UNITED STATES PATENT AND TRADEMARK OFFICE

10/701,026

Office Action Summary

DETAILED ACTION

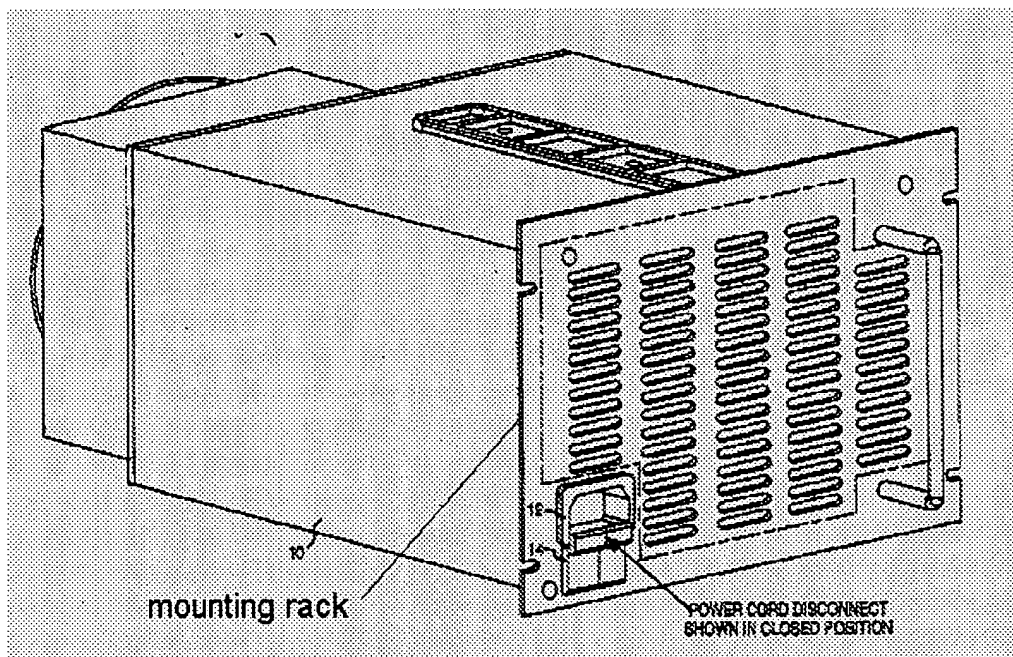
Regarding claim 2, Jarrett discloses the power supply further comprising a mounting rack (see following figure), and the insertion protection device is a slide (please note that element 14 slides between the positions shown in Fig.2 and 4) disposed in the mounting rack.

Regarding claim 3, Jarrett discloses the slide at least partially covering the connector (12) when the slide is in a locked state (as shown in Fig.2).

Regarding claim 4, Jarrett discloses a spring (22) acting on the slide for pushing the slide into a locking position (as shown in Fig.2), in which the connector (12) is at least partially covered by the slide.

Regarding claim 5, Jarrett discloses that the slide can be moved from the locking position only by applying force to the spring at two different positions (i.e. the two ends

of the spring). Please note that in order for the slide to be moved a tension force must be applied to the spring by the slide and a counteracting tension force is applied at the end in which the spring is attached to the housing.
